From: Simon O'Connell
Sent: 28 June 2021 14:04
To: [REDACTED]
Cc: Darek Podwiazka
Subject: Cambridge Road Sponsor review
Attachments: 210625 LSP SR Cambridge Road Rev S2-P01.xlsx

Sponsor Review Form

| Route Name | Cambridge Road LSP Cycle Scheme |
| Scheme Reference Number | 70014694-01-WSP-PO1-X-DR-HI-0100 |

| DRAWING No. 70014694-01-WSP-P01-X-DR-HI-0100-03 | REV. S2-P01 |

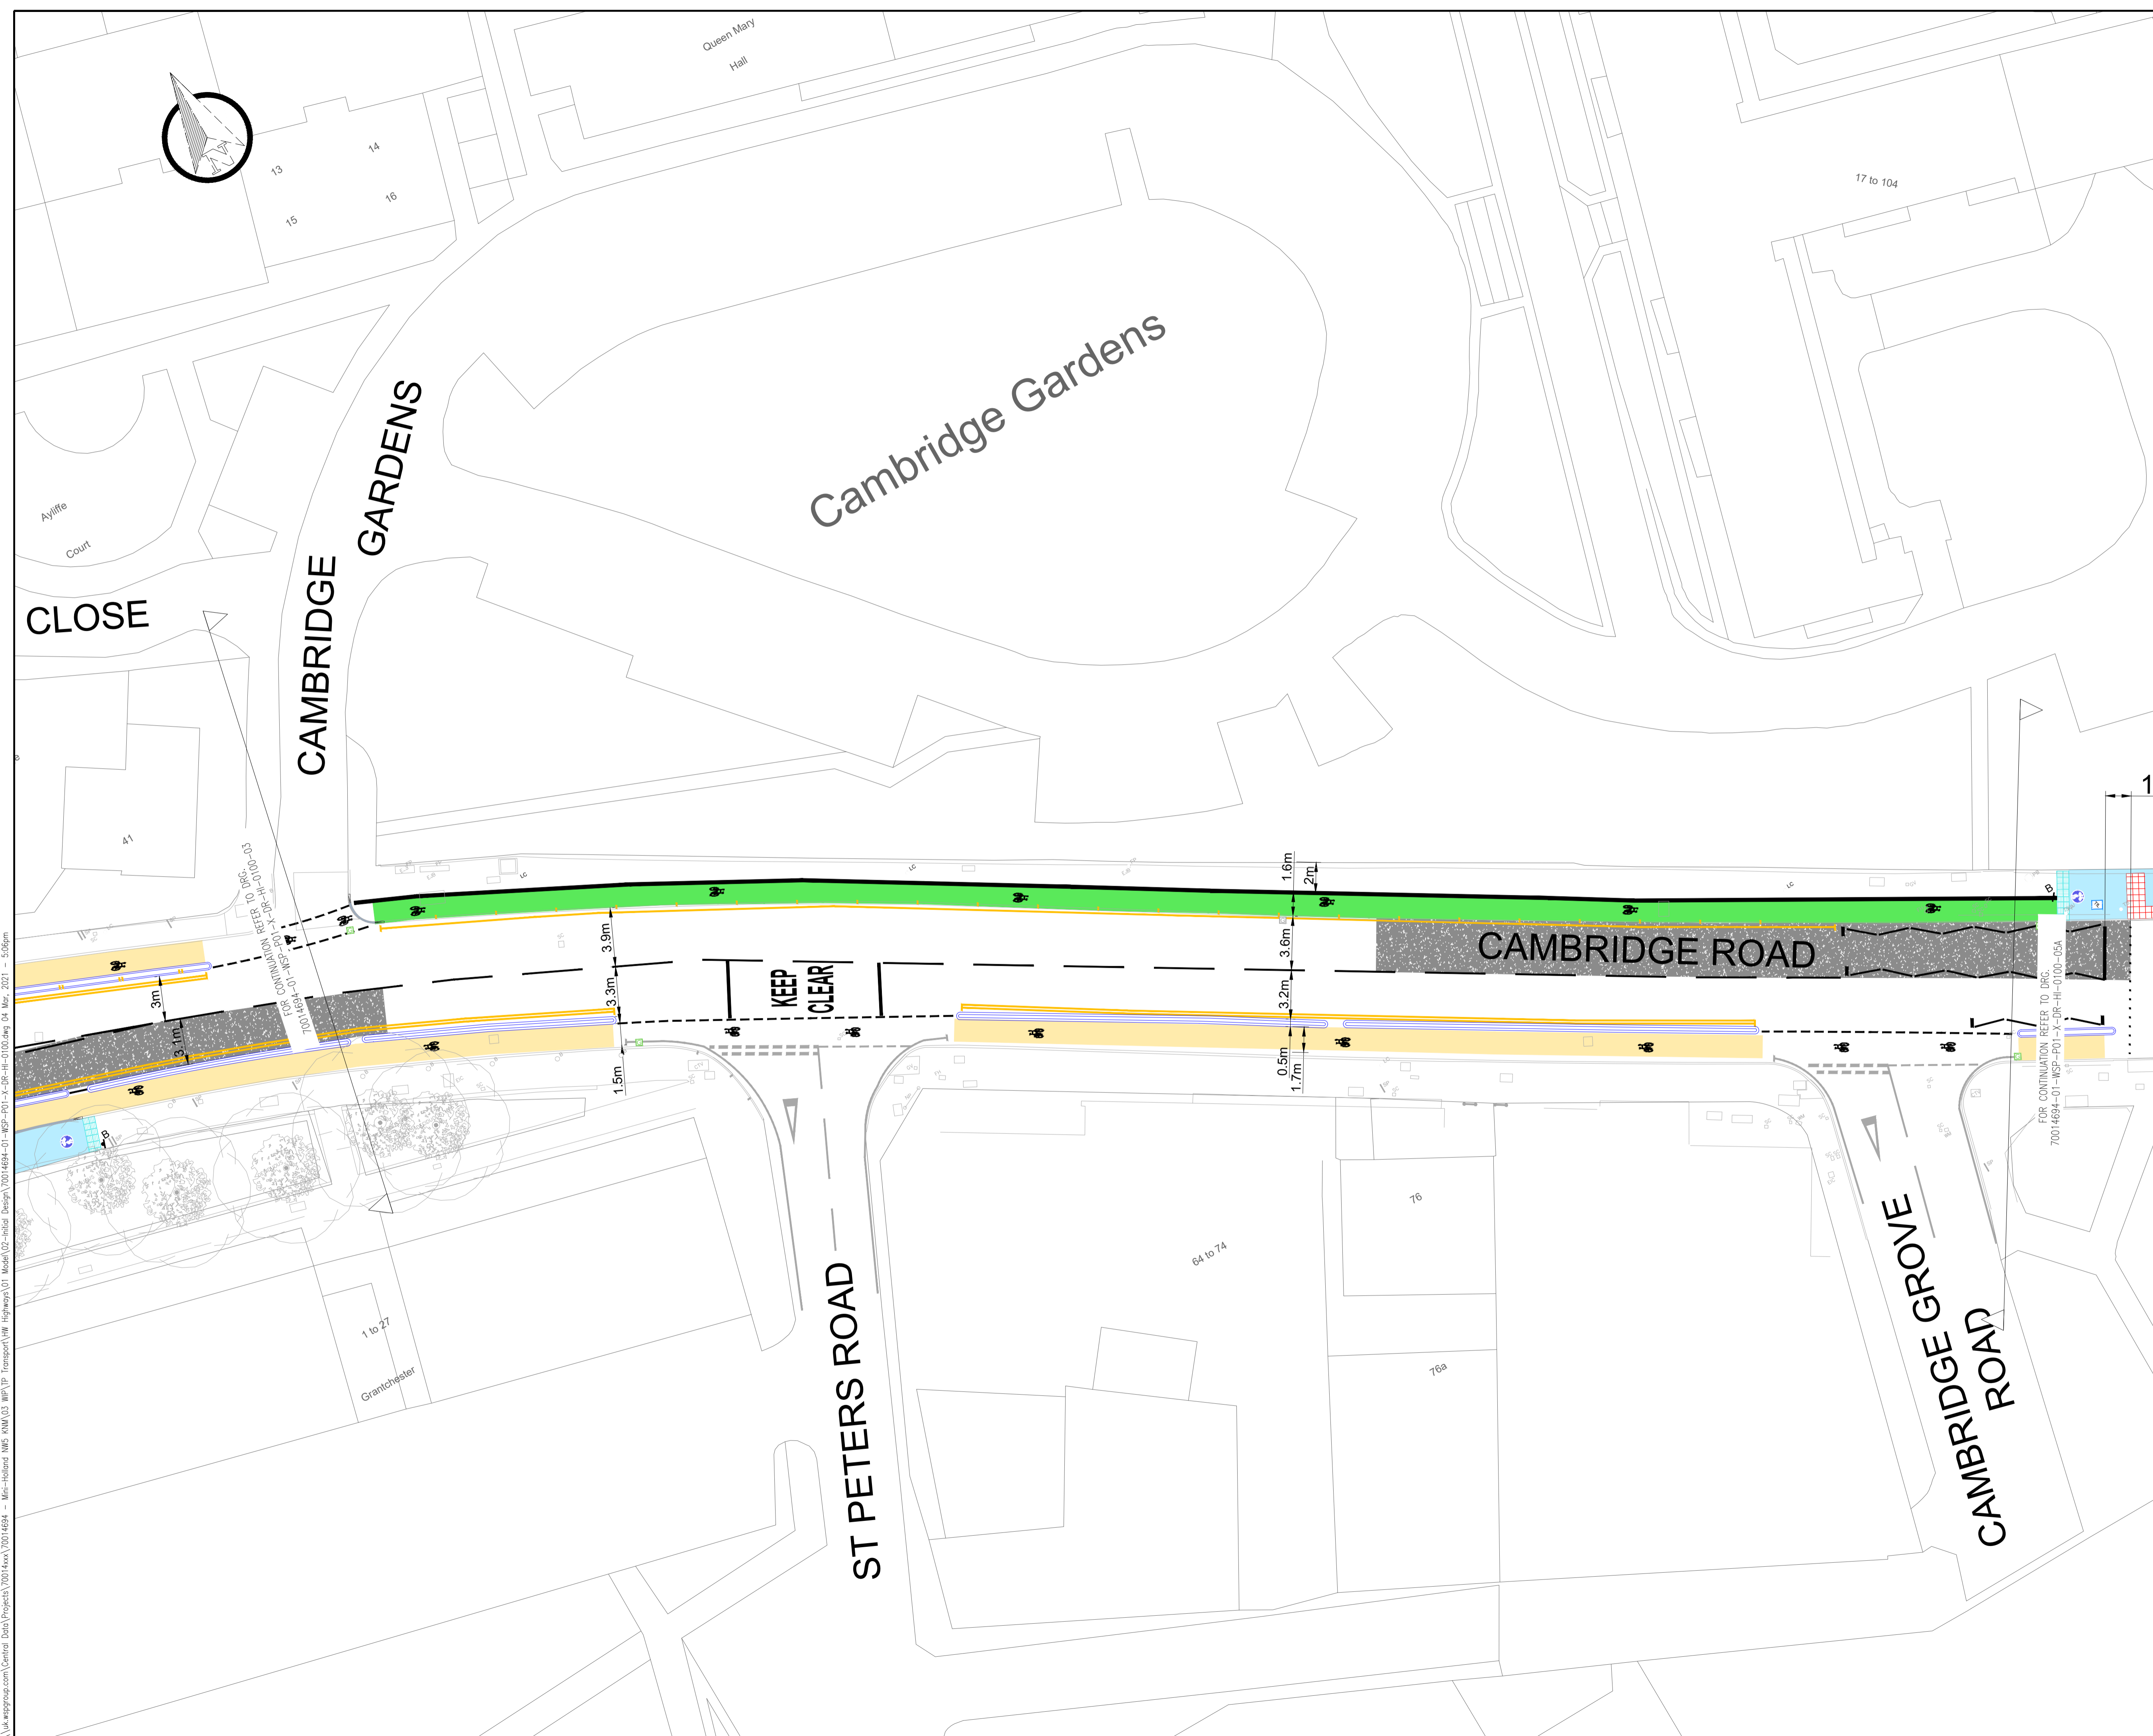
| SPONSOR TO COMPLETE | | | | | | | DESIGNER TO COMPLETE | | |
|---------------------|--|--------|------------------------|--------------------------------|----------------|---|--------------------------------|------------------|-------------------|
| 5 | 70014694-01-WSP-PO1-X-DR-HI-0100-03 | S1-P01 | GO CYCLE EASTERN ROUTE | Andy McMurdo (TfL Engineering) | 29/01/2021 | Please can the design of the Hawks Road junction be provided along with the proposed Method of Control when reviewed. Unclear how northbound cycles transition across the carriageway | | | |

TITLE: GO CYCLE EASTERN ROUTE
GENERAL ARRANGEMENT
SHEET 04 OF 10

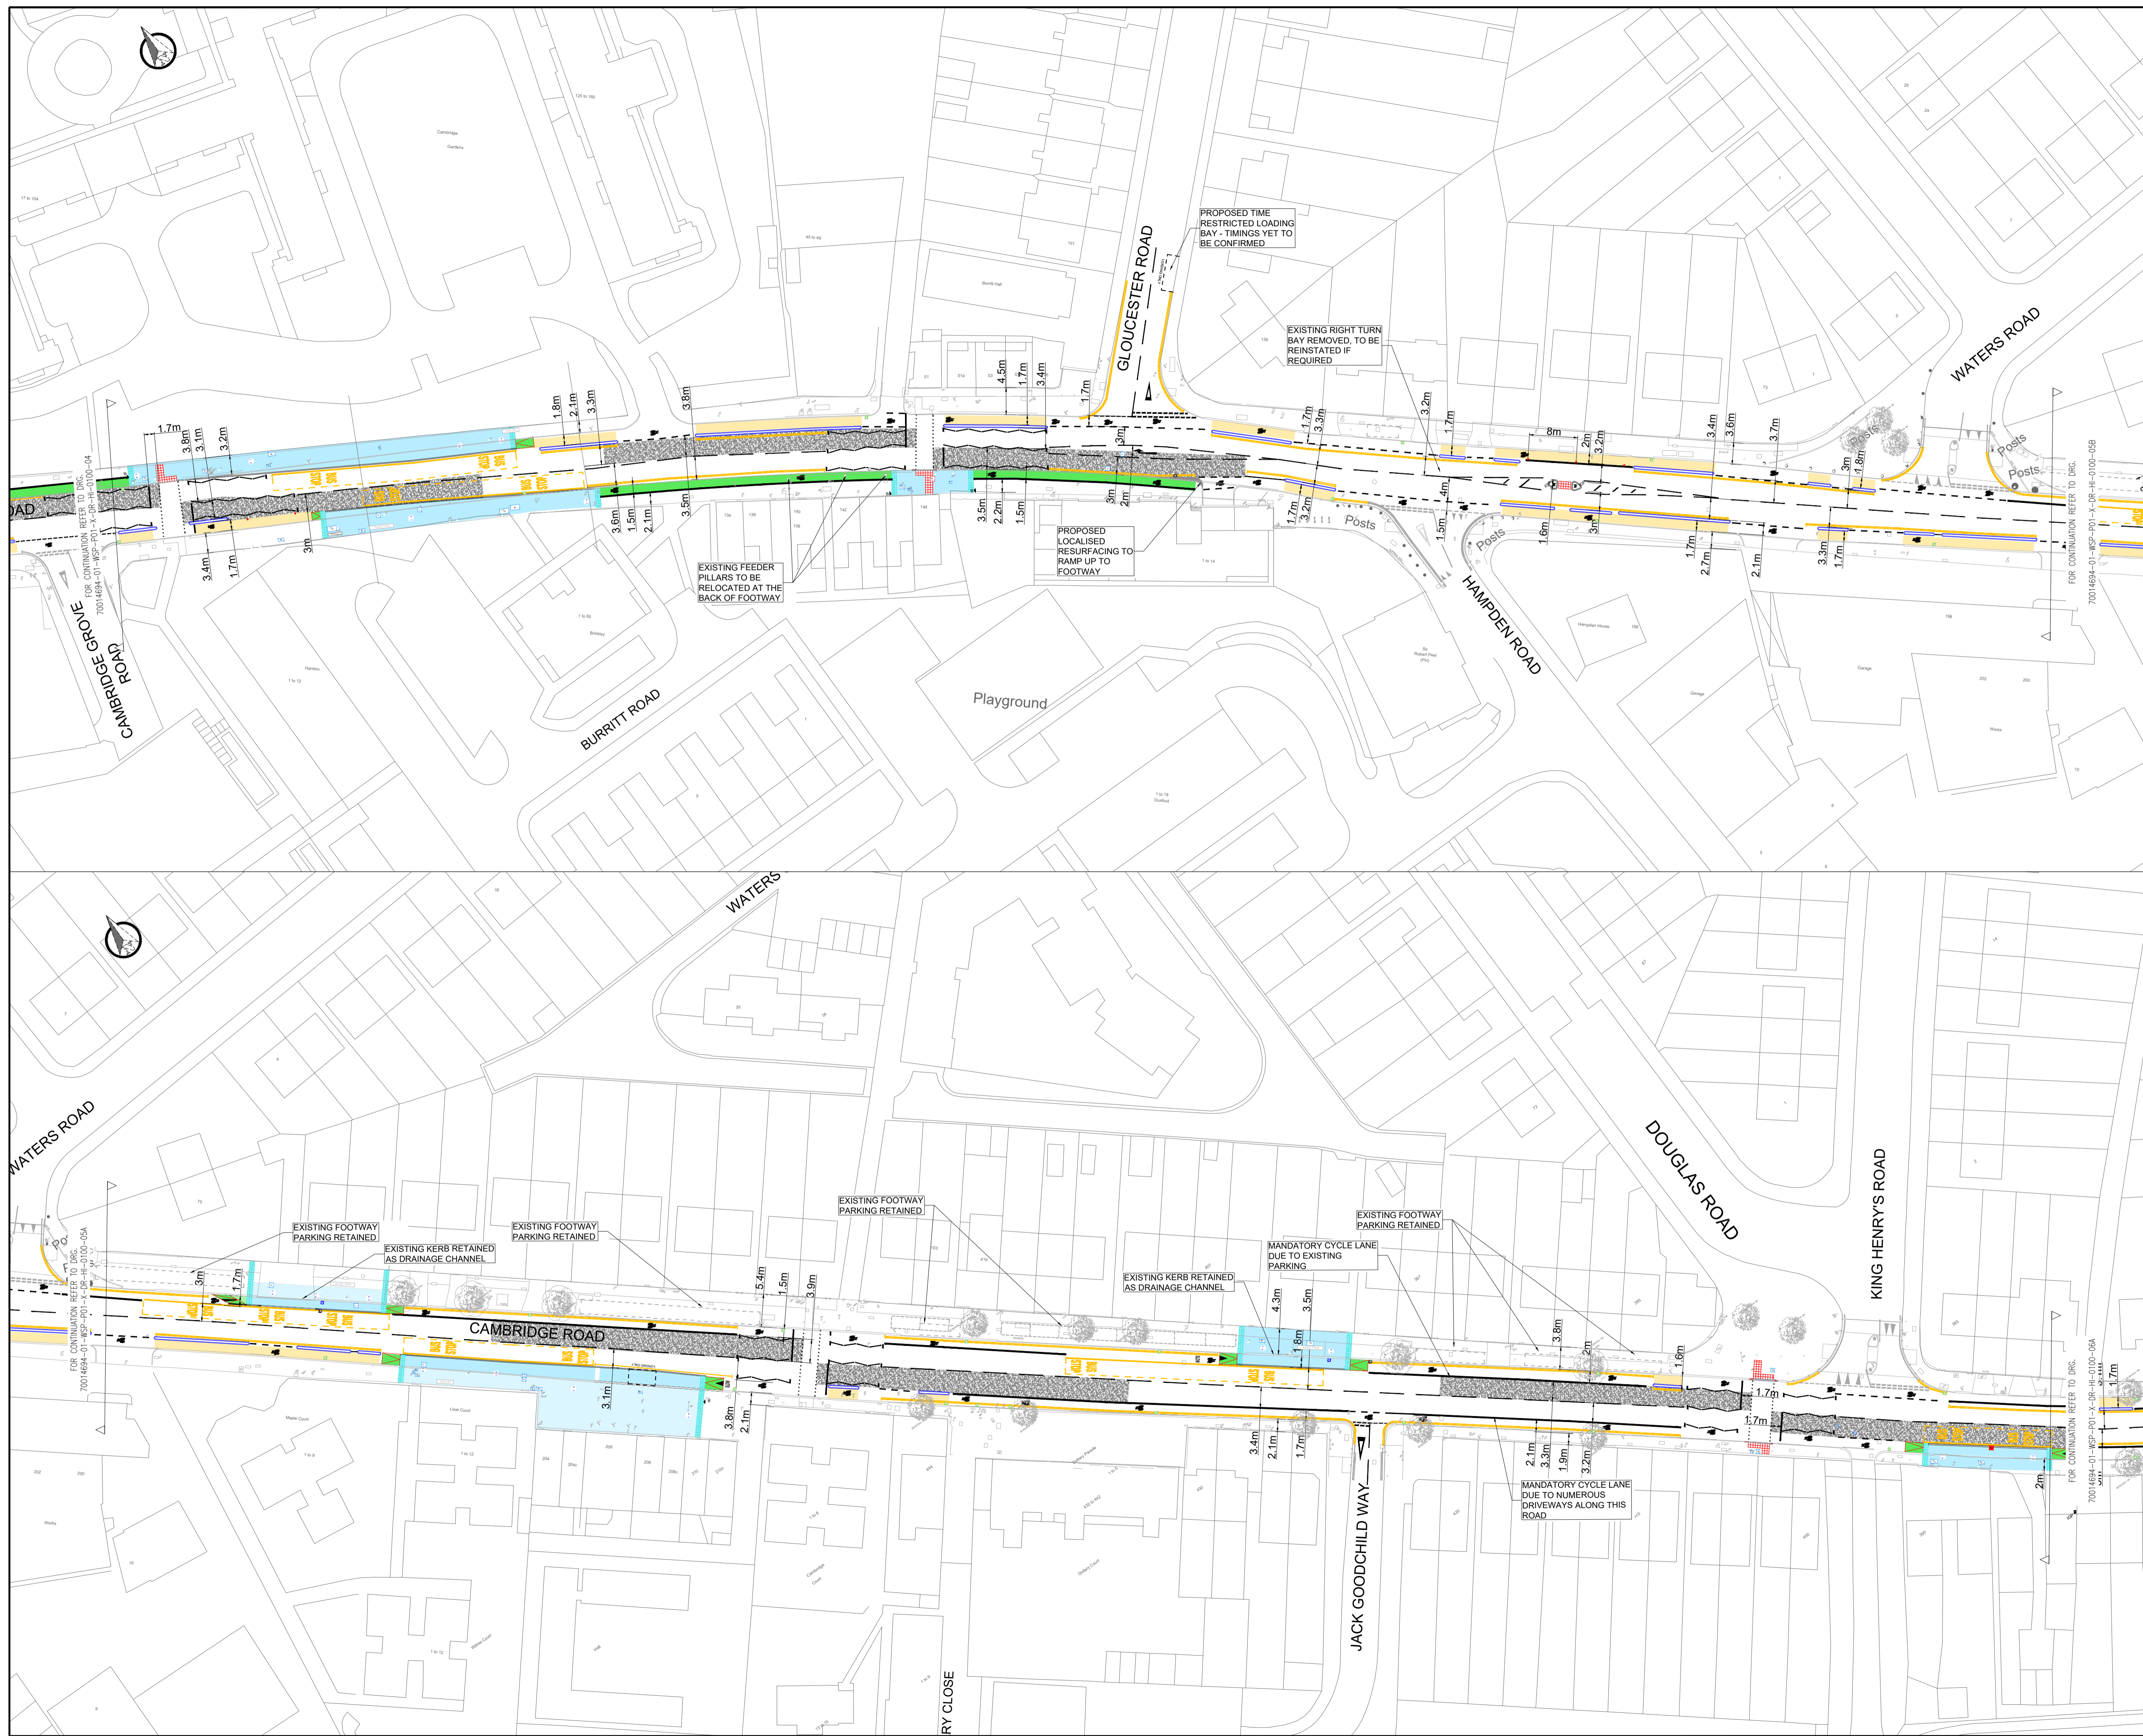
| SPONSOR TO COMPLETE | | | | | | | DESIGNER TO COMPLETE | | |
|---------------------|--|--------|------------------------|--------------------------------|----------------|---|--------------------------------|------------------|-------------------|
| 8 | 70014694-01-WSP-PO1-X-DR-HI-0100-04 | S1-P01 | GO CYCLE EASTERN ROUTE | Richard Pink (TfL Engineering) | 01/02/2021 | Numerous lighting columns and posts in proposed cycle track. Are these being relocated? What is the effective footway width between wall and posts? | | | |
